TRAILS AT CROWFOOT AMENDMENT NO.1

LANDSCAPE PLANS

FILING 14, MIXED USE

TRAILS AT CROWFOOT
FILING 14 LANDSCAPE PLANS
PARKER, COLORADO

L1.0

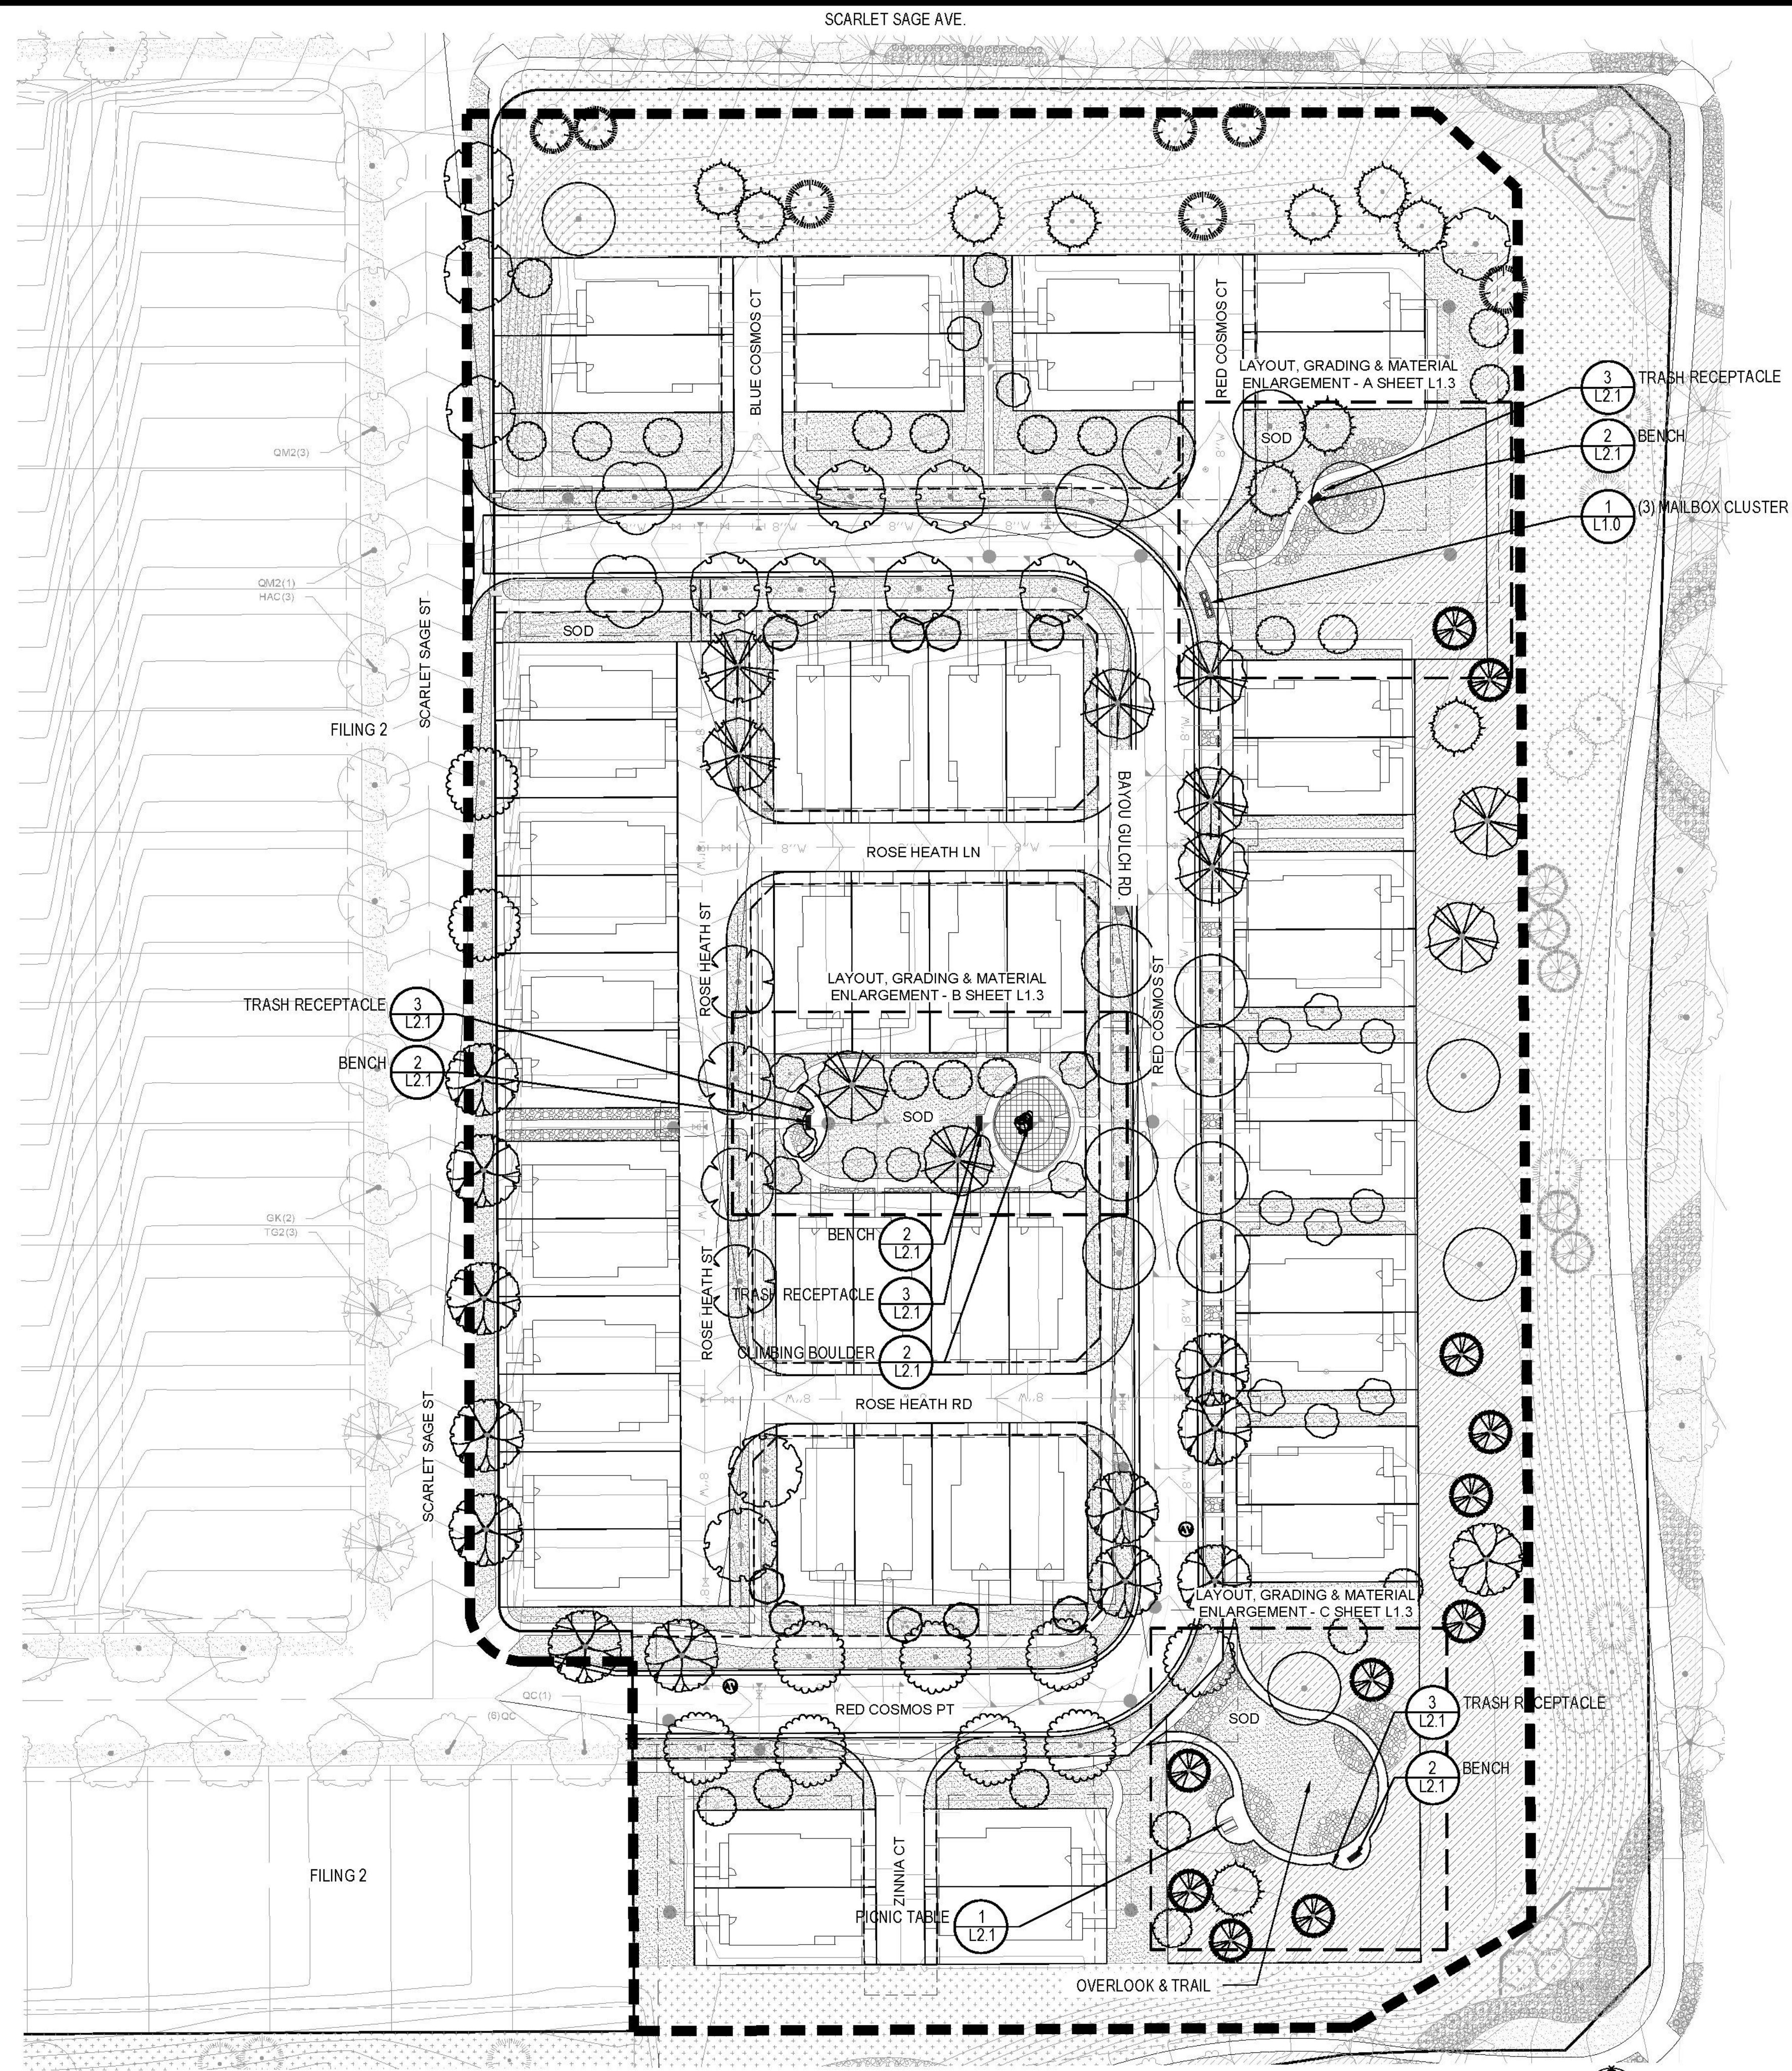
57 shrubs removed from the native area along Scarlet Sage Avenue.
6 evergreen trees added to replace removed shrubs.
